Removing Barriers to Low Impact Development (LID)

LID Technical Standards Review

Technical Memorandum #1 Bioretention Details and Standards Review

May 2017

Municipality Department Name	APPROVED BY:	STREET BIORETENTION FACILITY (FLAT/PLANTER, ON-STREET PARKING, SIDEWALK, WITHOUT UNDERDRAIN)	STANDARD PLAN NO. SW-1
	VERSION: 12/16/2016	USE WITH STANDARD SPECIFICATIONS FOR PUBLIC WORK CONSTRUCTION

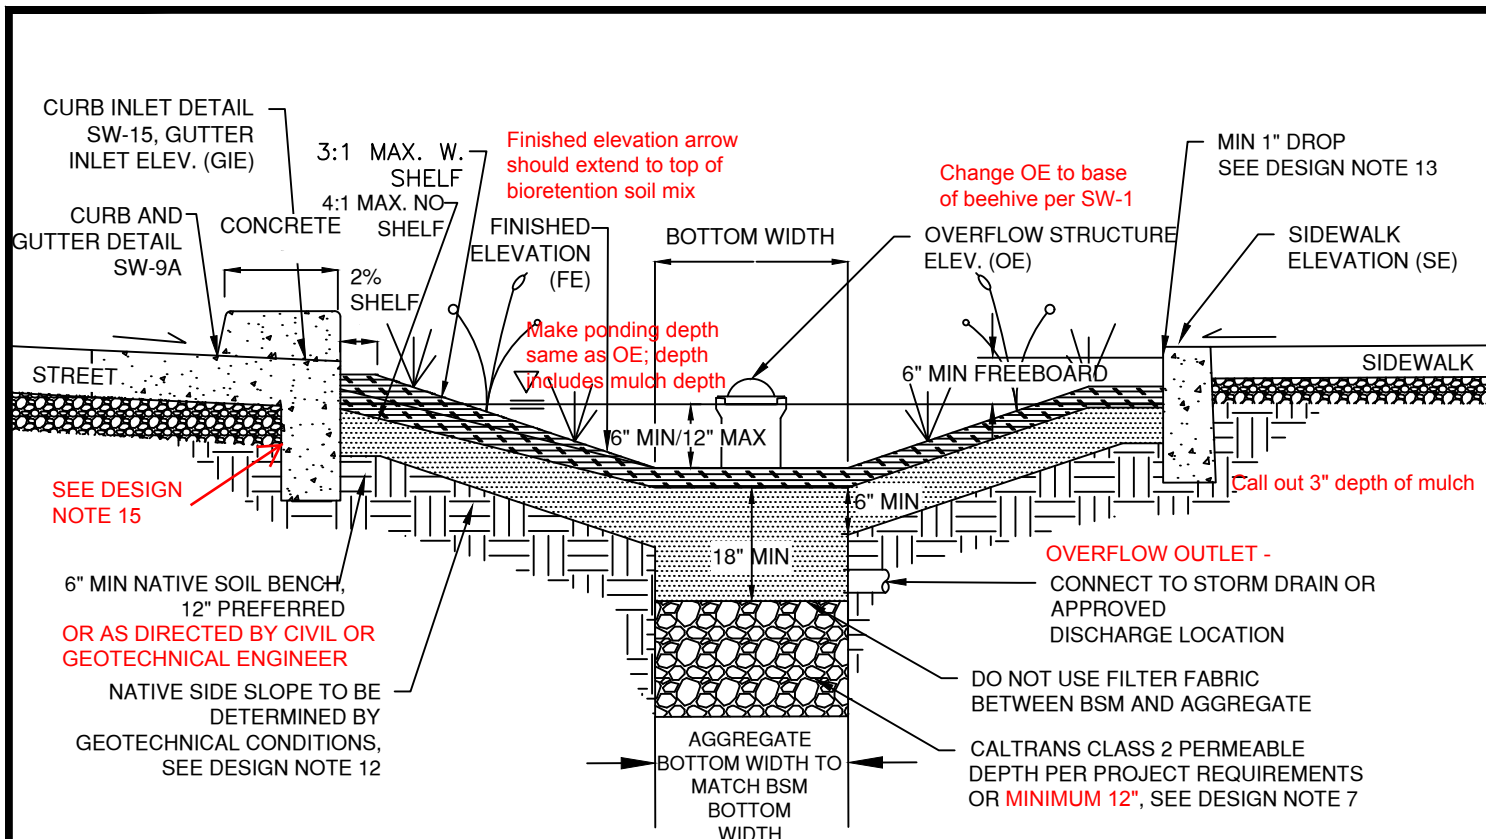
Change drawing to reduce width of BSM over native side slope and increase width of aggregate section (by a lot)

Municipality Department Name	APPROVED BY:	PARKING LOT BIORETENTION FACILITY (FLAT/PLANTER, WITHOUT UNDERDRAIN)	STANDARD PLAN NO. SW-3
	VERSION: 12/16/2016	USE WITH STANDARD SPECIFICATIONS FOR PUBLIC WORK CONSTRUCTION

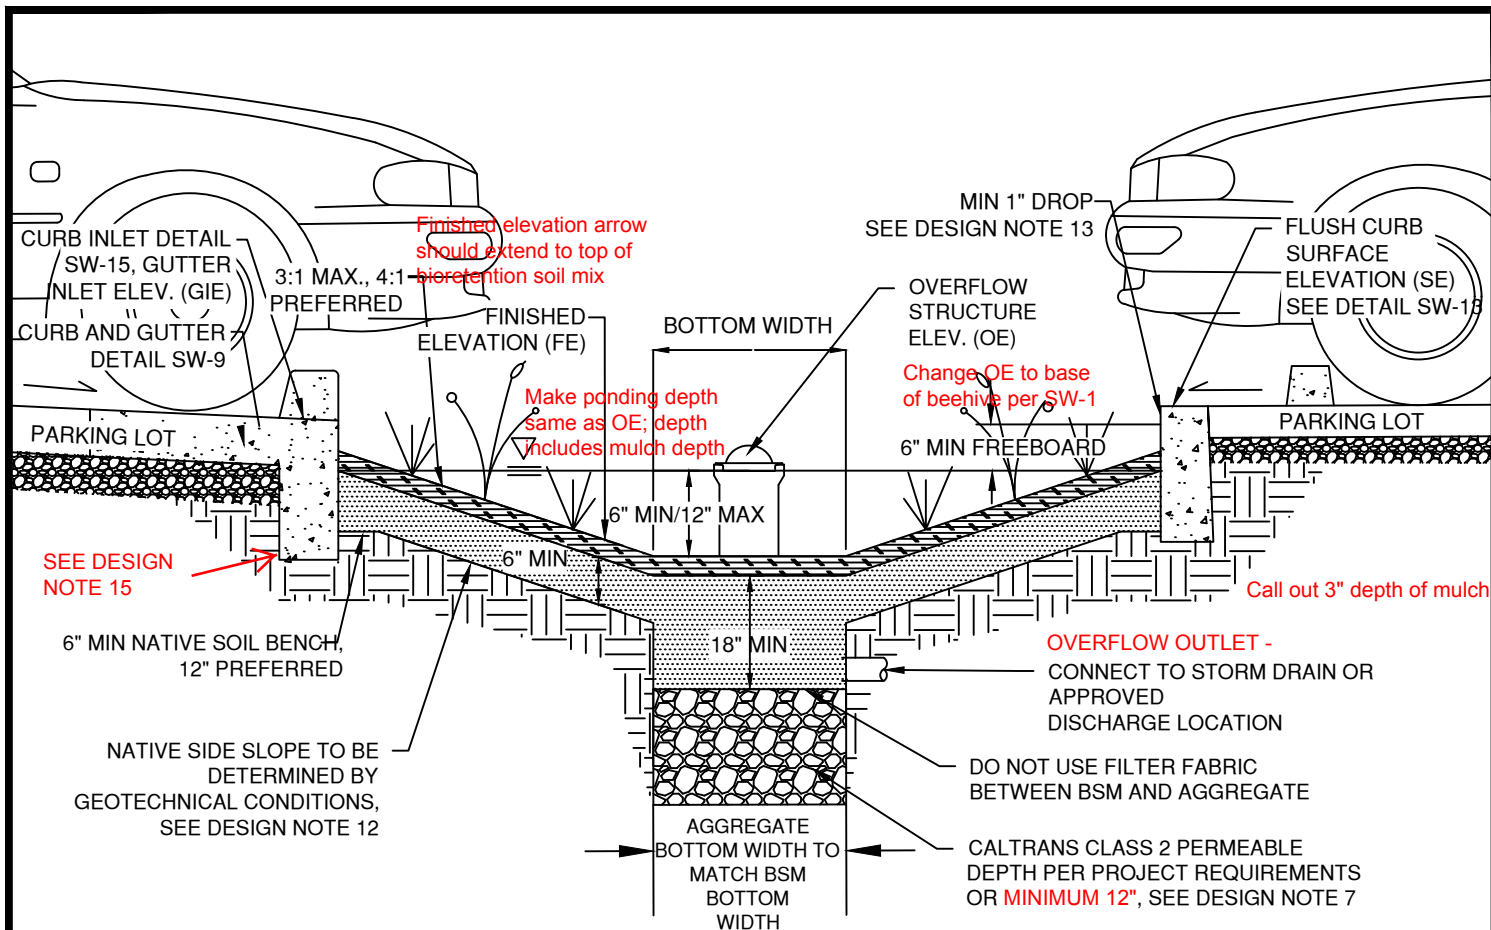
Call out 3" depth of mulch

CURB CUT INLET FOR PLANTERS

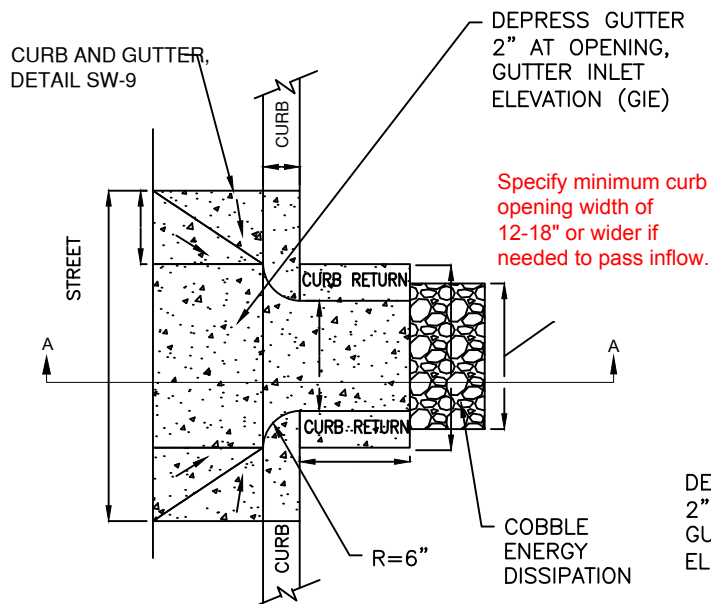
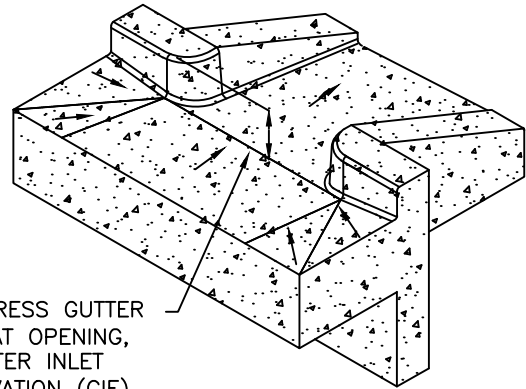
Specify minimum curb
opening width of
12-18" or wider if
needed to pass inflow.

SECTION A-A

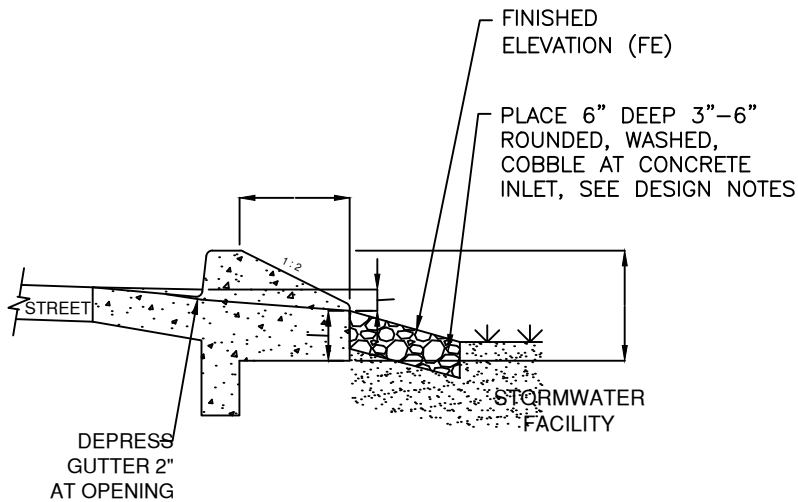
FE should be top of BSM
for consistency with other
details

Municipality Department Name	APPROVED BY:	DRYWELL STORMWATER BMP	STANDARD PLAN NO. SW-24
	VERSION: 12/16/2016		SHEET 1 OF 2

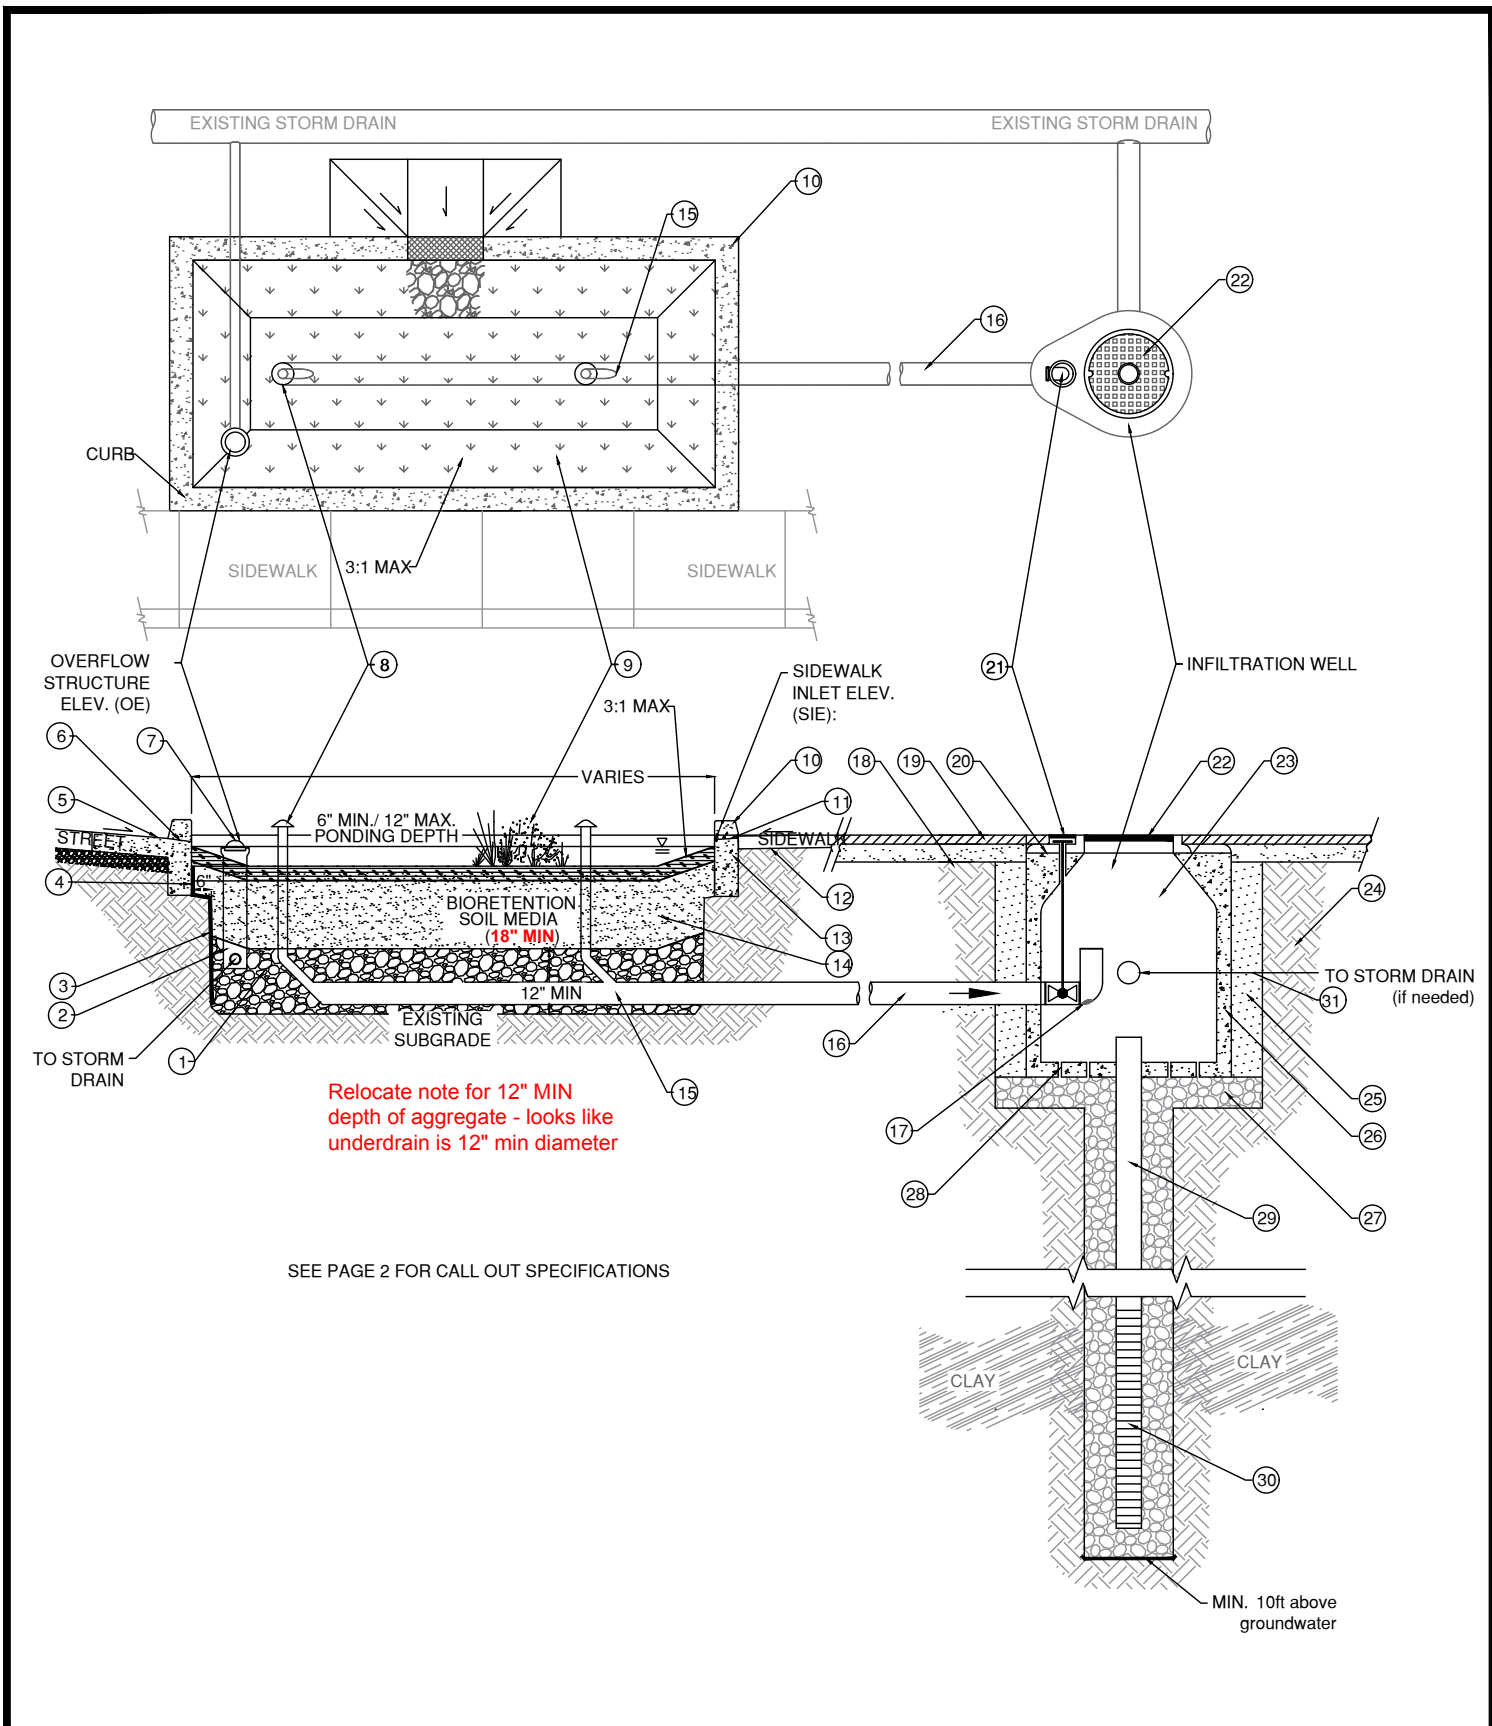
The LIDI bioretention/dry well system design (Detail SW-24) and the accompanying guidance memorandum by Geosyntec was reviewed with regard to clarity, technical validity, and robustness. In our opinion, this is a very robust and effective design for stormwater capture via deep infiltration of treated stormwater. The memorandum provides clear guidance on the design of the bioretention/dry well system and a technically sound basis for the design. The plan view and longitudinal section on Detail SW-24 clearly illustrate the construction of the system. The shut-off valve is an important feature to prevent hazardous material spills from breaking through the bioretention facility and entering the dry well, further minimizing the risk to groundwater quality.

With the exception of one minor clarification on the design detail itself, our comments are focused on edits to the SW-24 design and construction notes to make the notes more clear and correct some inaccuracies. Comments on the notes are provided in the table in Attachment C.
